**PRODUCT  
SUPPORT  
BULLETIN # 484**

TOOL(S) \ PRODUCT(S) AFFECTED: 8950 Series II and III Vacuum Cleaners, 8955 Series II and III & 4 Vacuum Cleaners

**SUBJECT: substituting Cartridge Filter 49-90-1830 for 49-80-0285 Cloth Filter Bag**

**Series II and III**

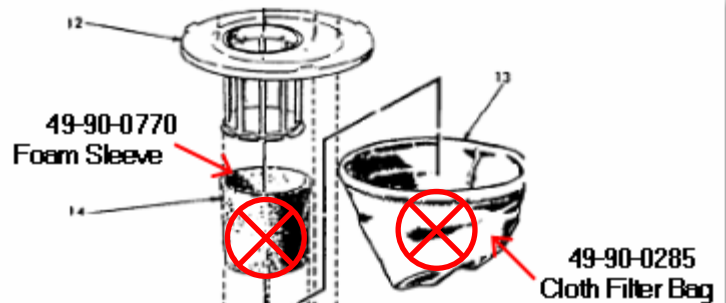
Anyone servicing or needing a Cloth Filter Bag 49-90-0285 can substitute the Cartridge Filter 49-90-1830. Foam Sleeve must be removed and discarded\*.

**Series 4**

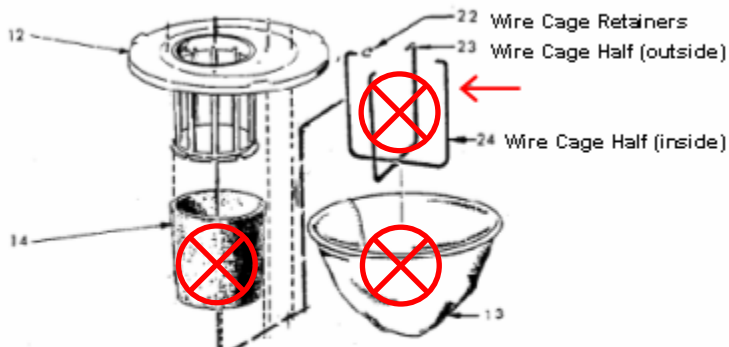
\* **Series 4** 8955 Vacuum Cleaners will have a wire cage (inside & outside) half along with four [4] wire cage retainers. These items will need to be removed and discarded when installing a cartridge filter. Cage retainer screws will be reused.
